TO: Mayor Rochelle Robinson
ATTN TO: Patrice Williams, Community Development Director
FROM: Douglas R. Hooker, Executive Director
RE: Development of Regional Impact (DRI) Review

Name of Proposal: Riverside West Business Park (DRI #3080)

DRI #3080

Development of Regional Impact Assessment of Consistency with the Regional Transportation Plan

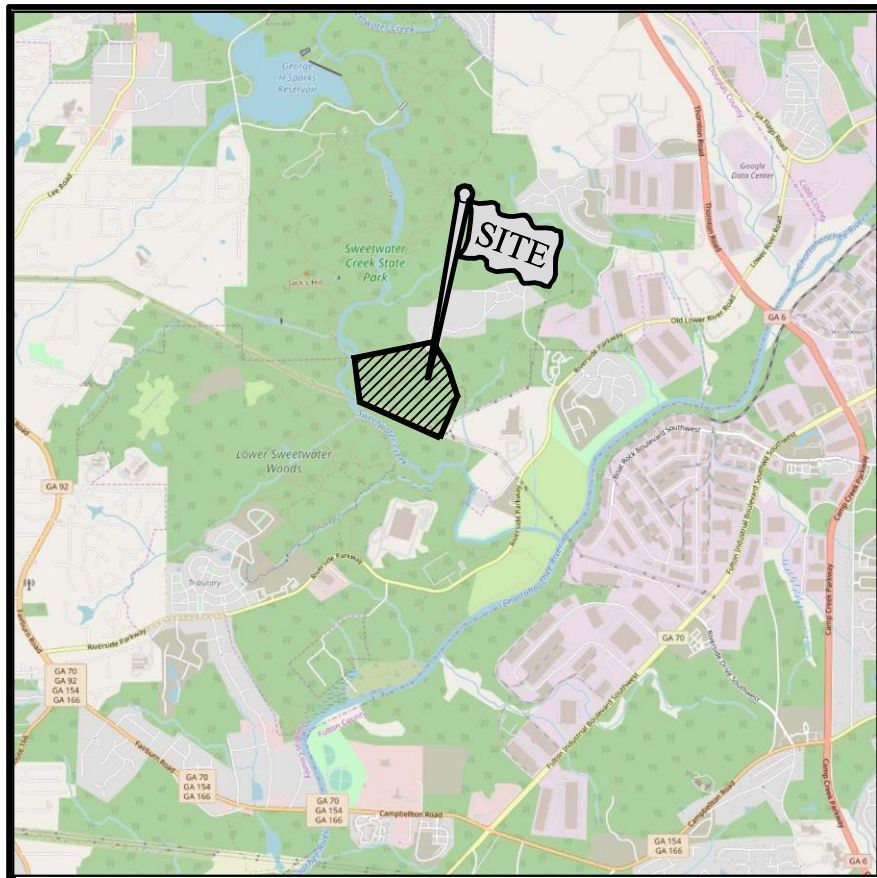
The USGS coverage for the project area shows no blue-line streams on the property. Based on the submitted site plan, the property does not extend to the banks of Sweetwater Creek, but portions of the property may be within 75 feet of the Creek. In addition, the site plan shows five unmapped streams on the property, three of which will be affected by the proposed project, with buildings, parking areas and outdoor storage built over them. No buffers are shown on any of the streams. If these streams are subject to the City's 50-foot stream buffer and additional 25-foot impervious setback, they should be shown, and any intrusions in the buffer or setback will be subject to the requirements of the City of Douglasville's Stream Buffer Ordinance. These streams, as well as any other waters of the state on the property, are also subject to the State 25-foot State Erosion and Sedimentation Act buffer, and any intrusions into those buffers may require variances. In addition, the City buffers should be shown along any portion of the property within the buffer or setback area of Sweetwater Creek.

DRI SITE PLAN
1
ROOKER
DESIGN :: BUILD :: DEVELOP

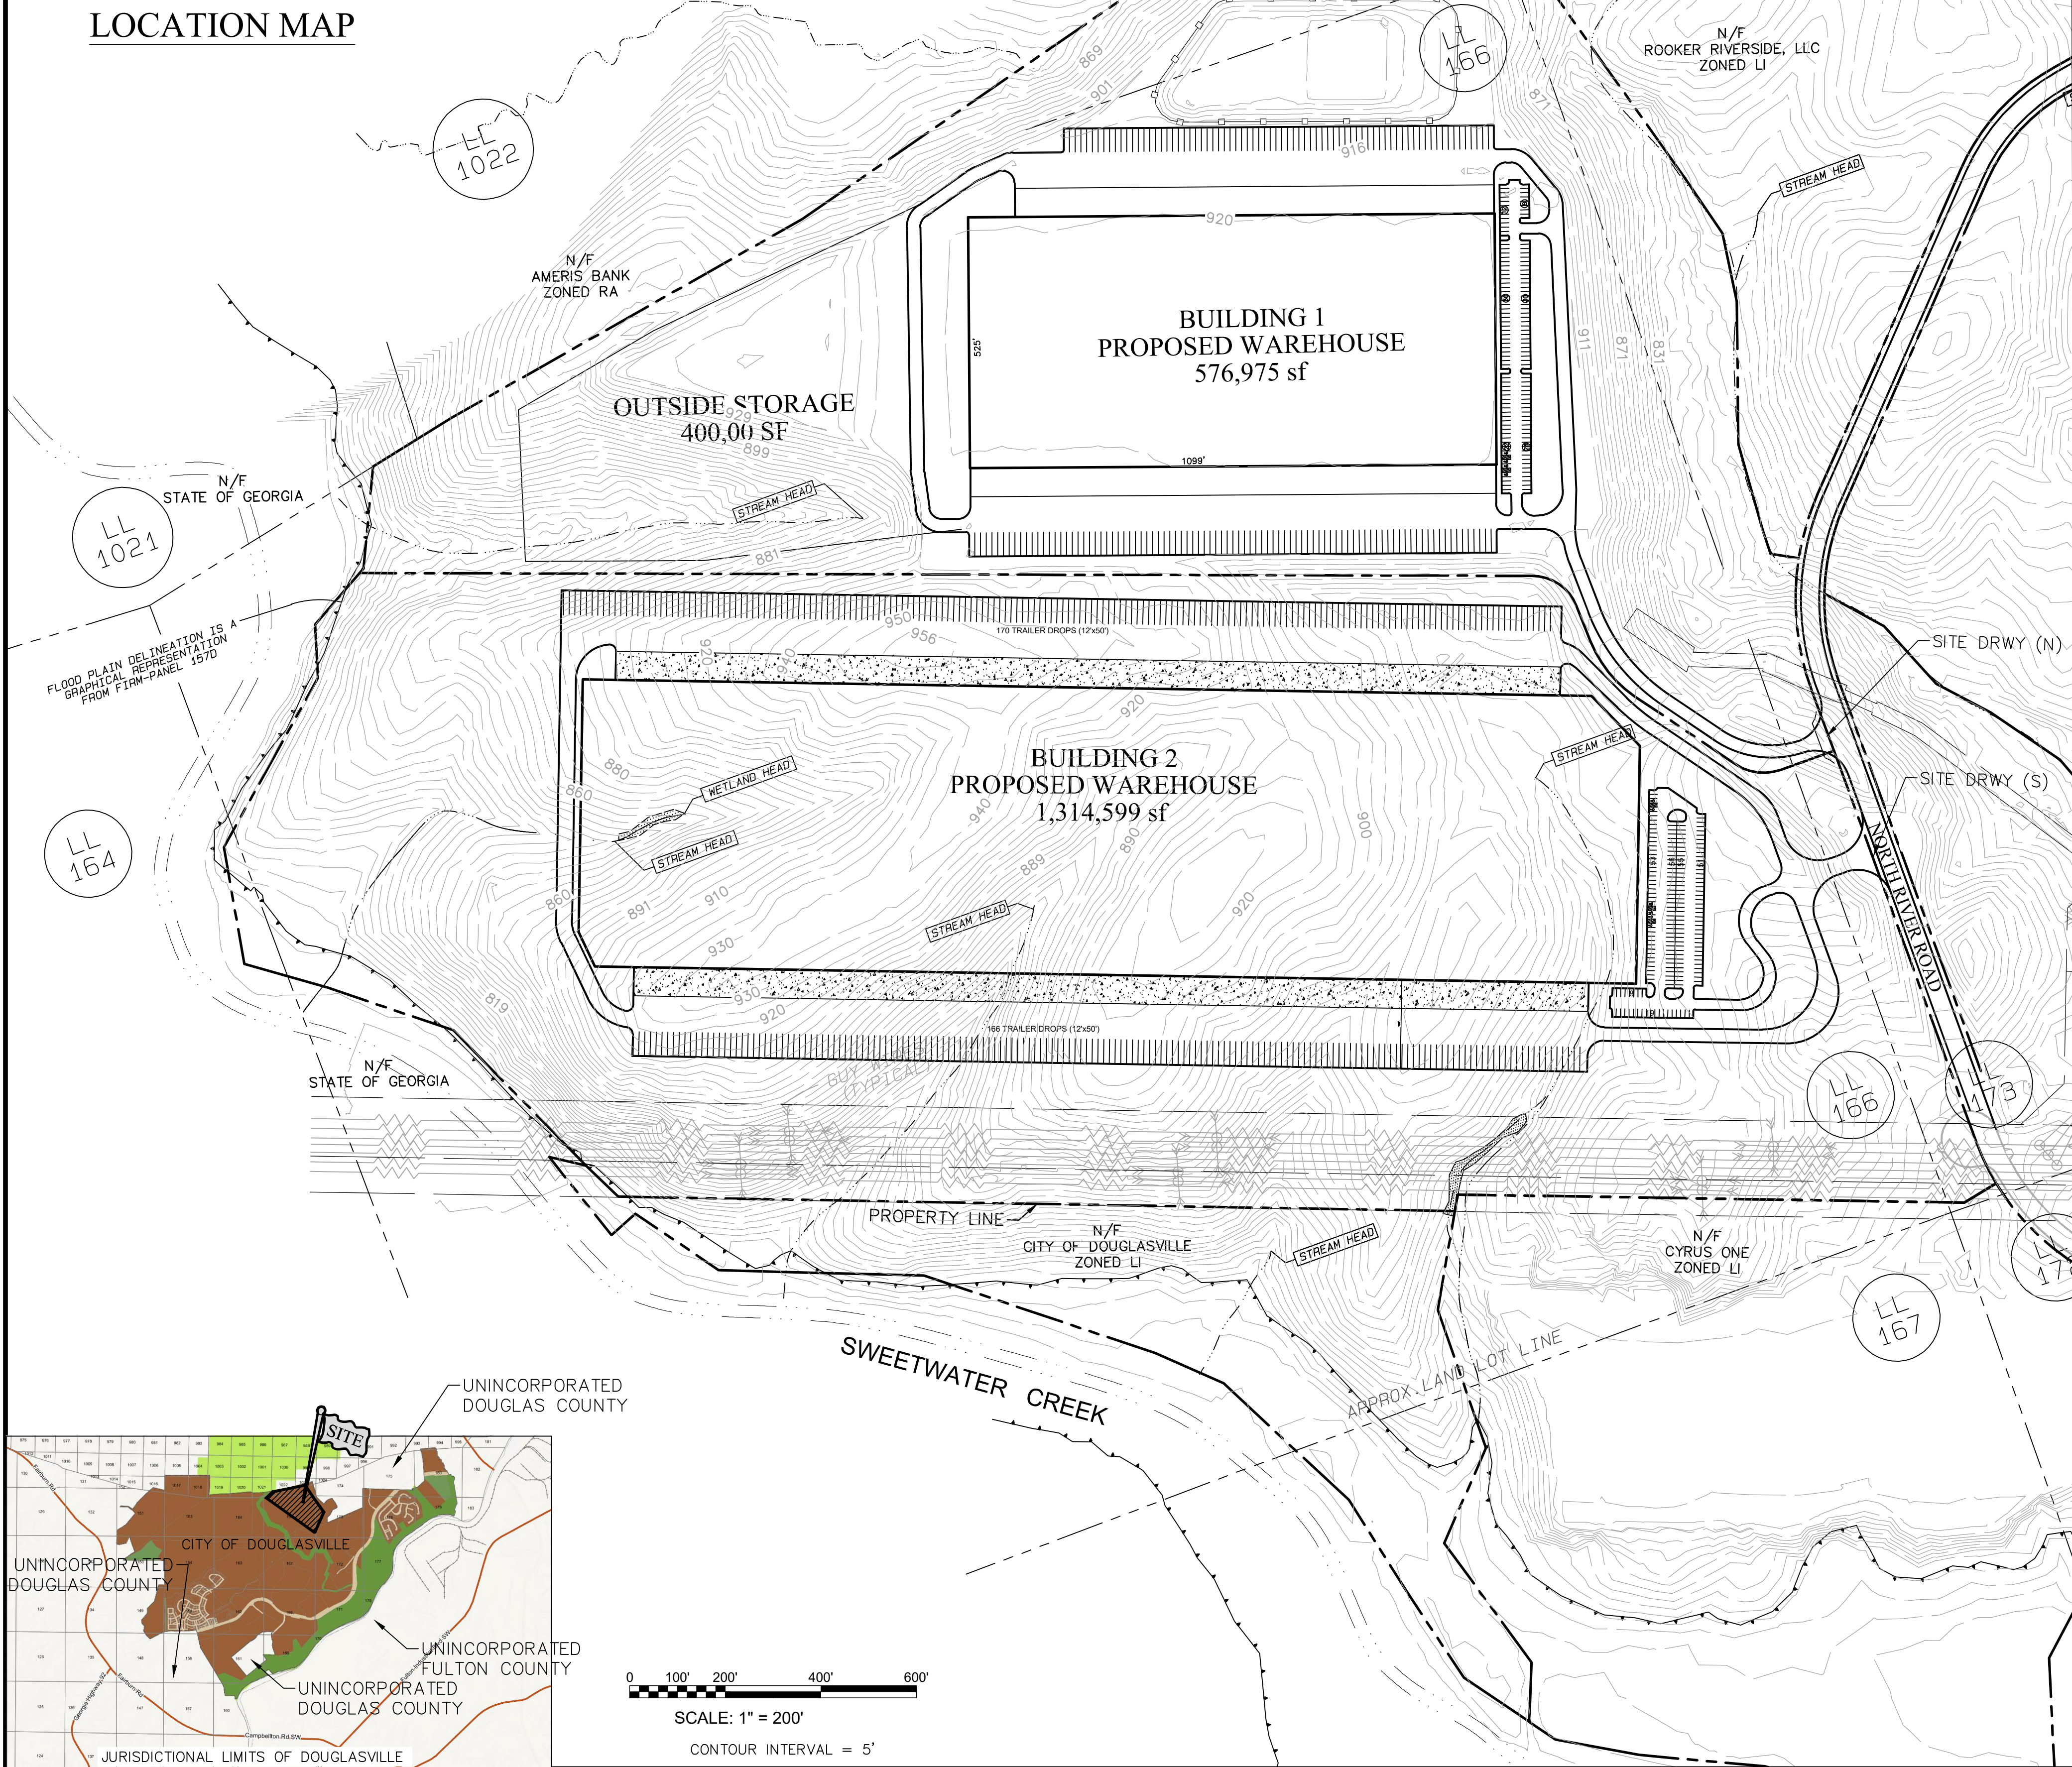
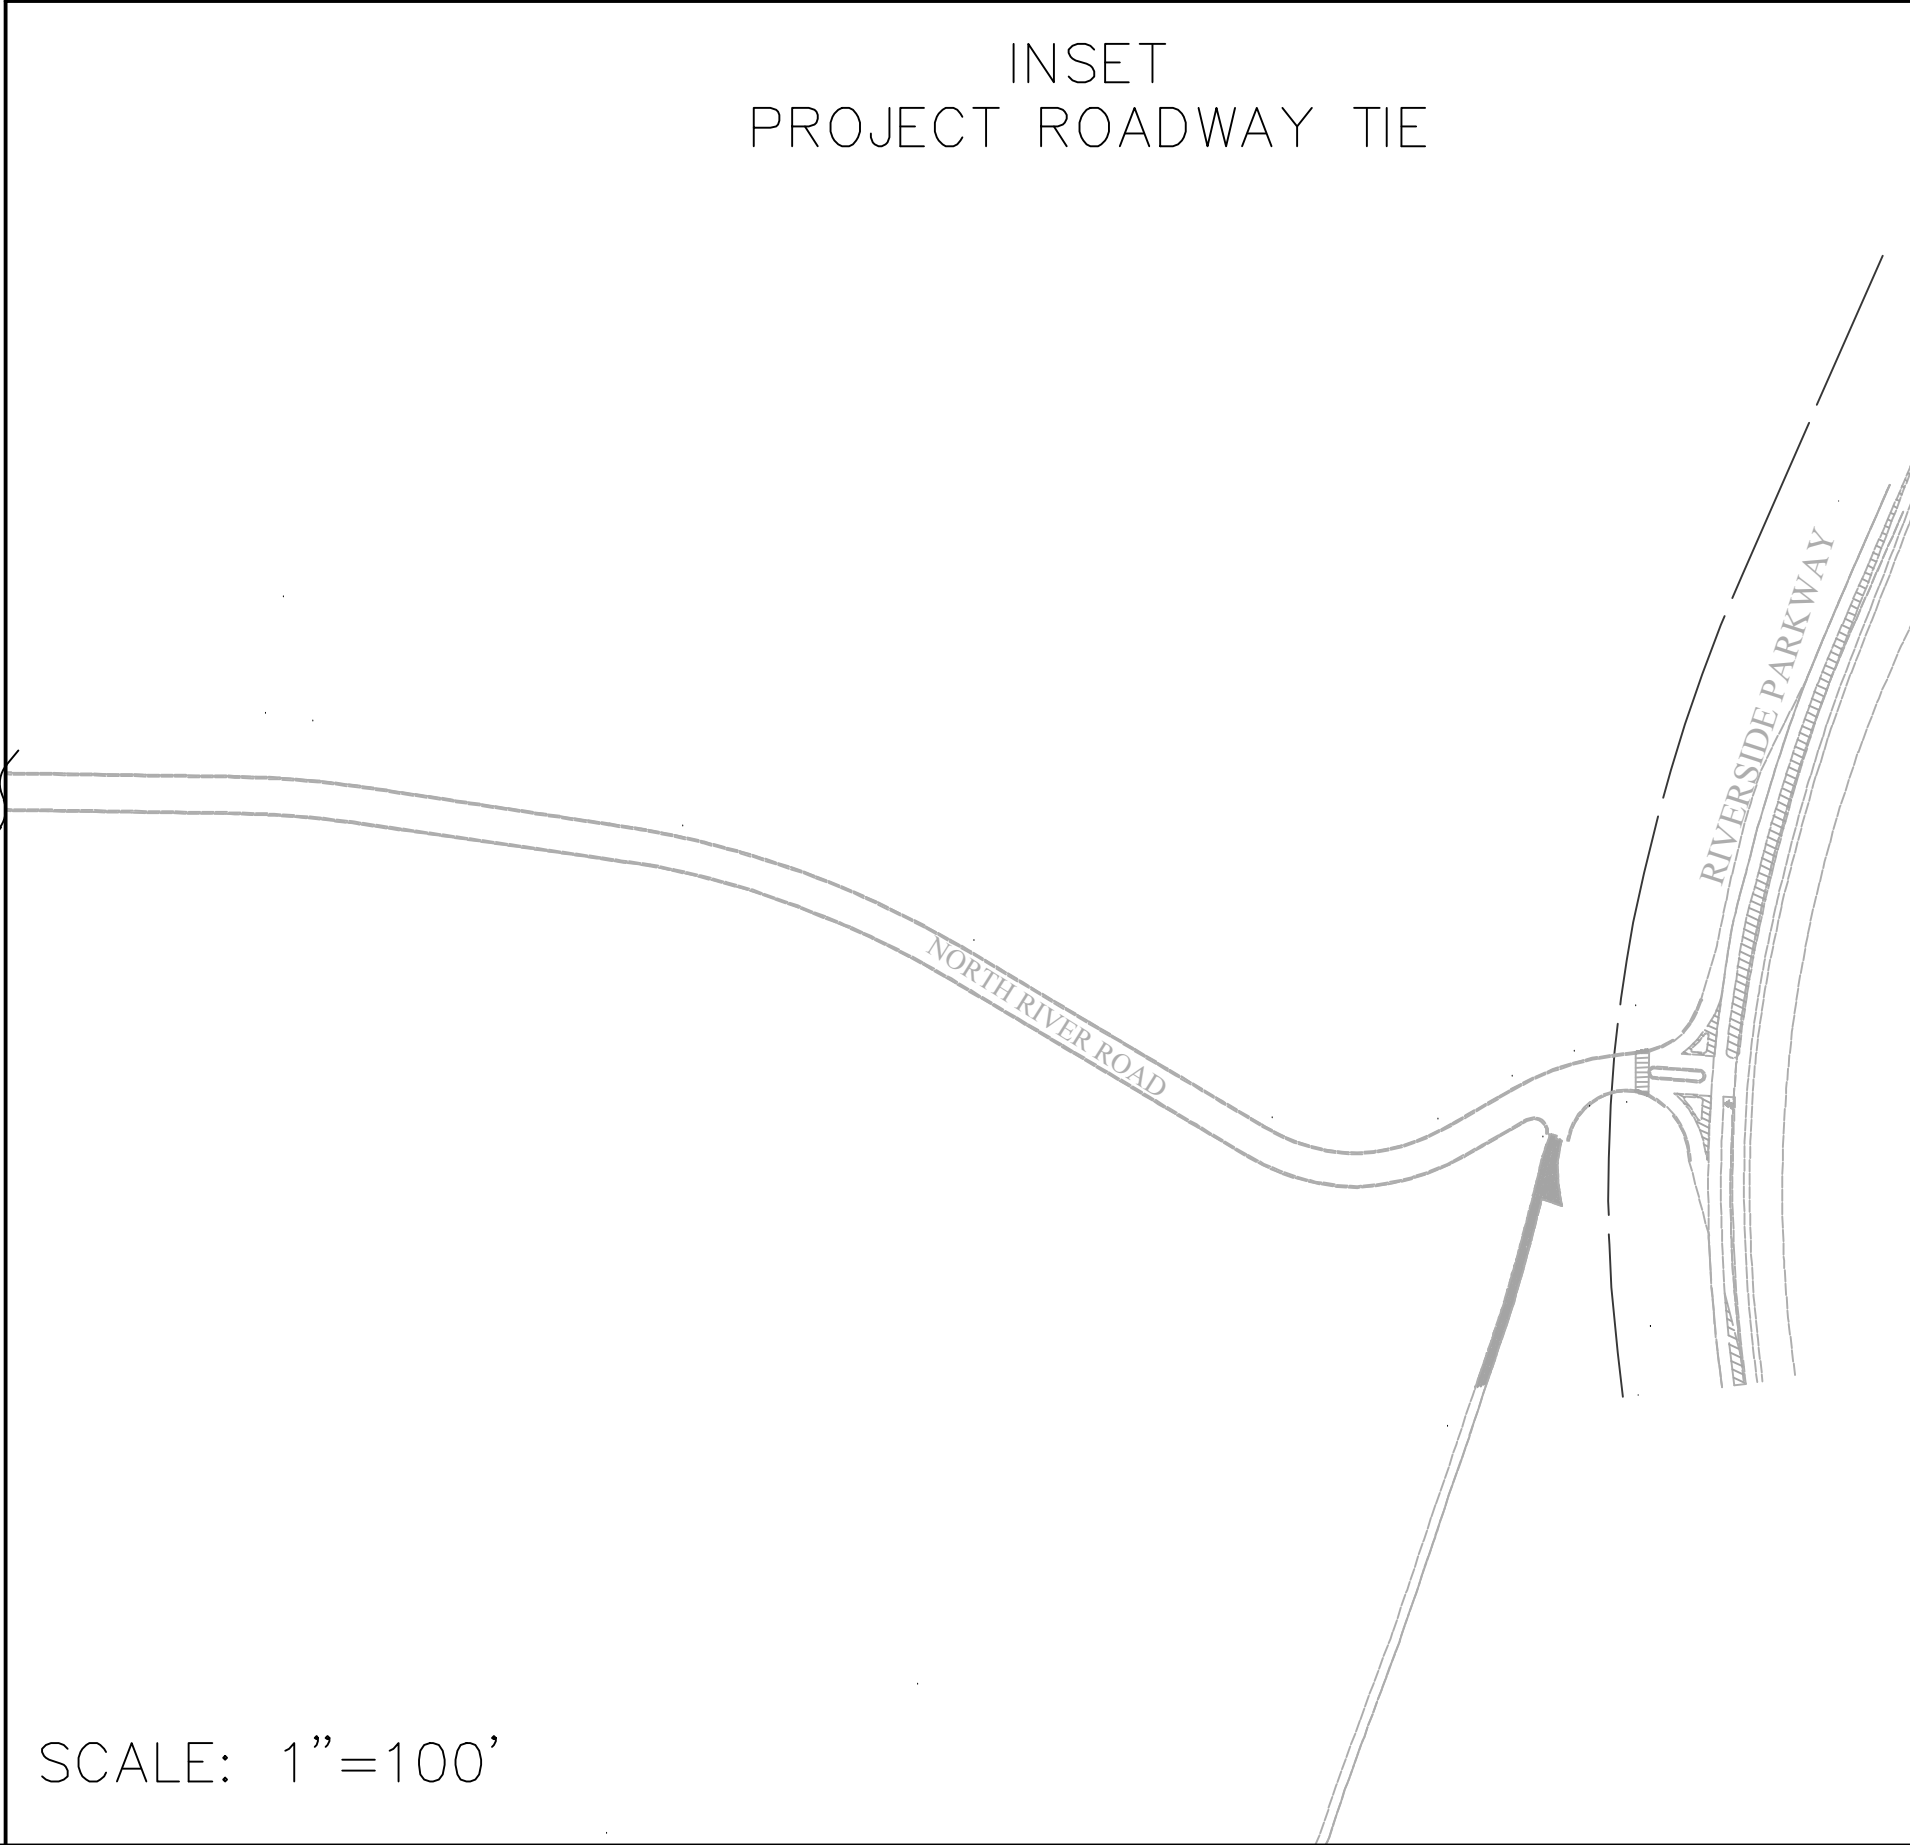
The site plan depicts two driveways proposed on North River Road.

No facilities are proposed for pedestrian use internal to the site. The truck traffic combined with vehicle traffic makes hinders safe bike ped use on site.

Two drive access points are proposed for the development, one to each building, however the proposed site plan does not depict separate driveways for truck and vehicle traffic.
